Product change information (PCN)

PCN No.:	CAB180044	Date:	27.06.2018
Product:	According to the product list

Replacement of the O-ring with form seal

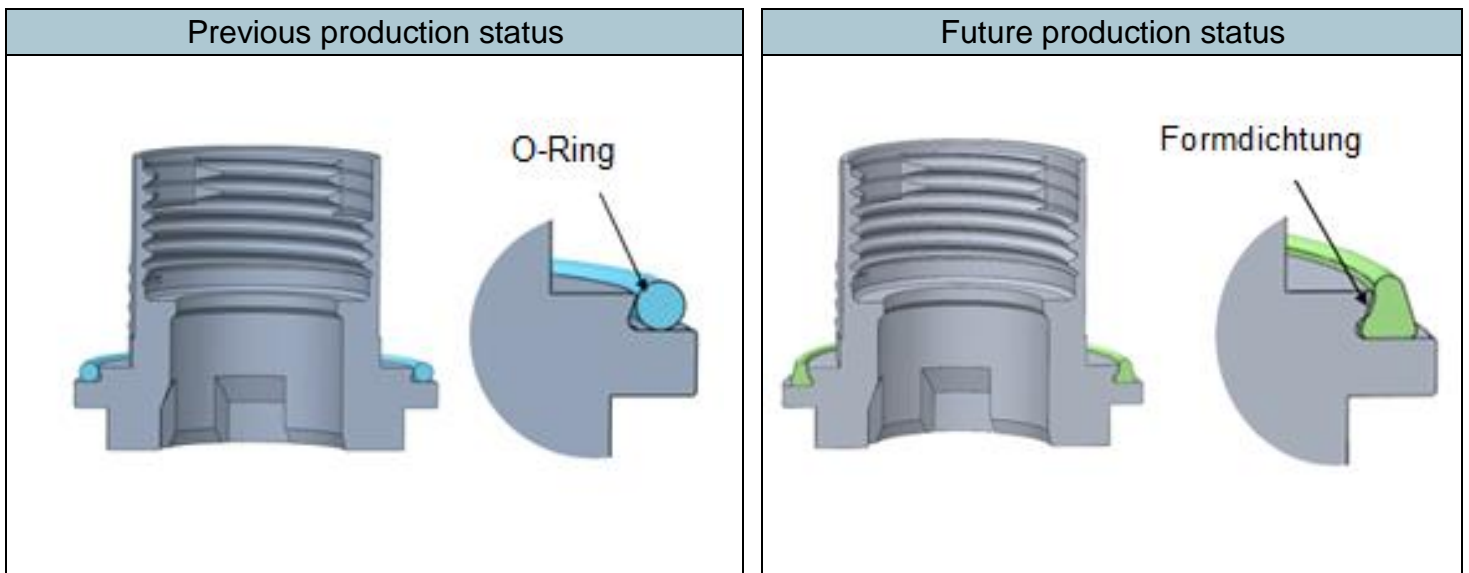
In addition to product modification AAB17006, the O-ring of the articles mentioned in this PCN is also exchanged for a molded seal.
 This improves the fit of the seal.
 The electrical and technical properties of the products remain unchanged.
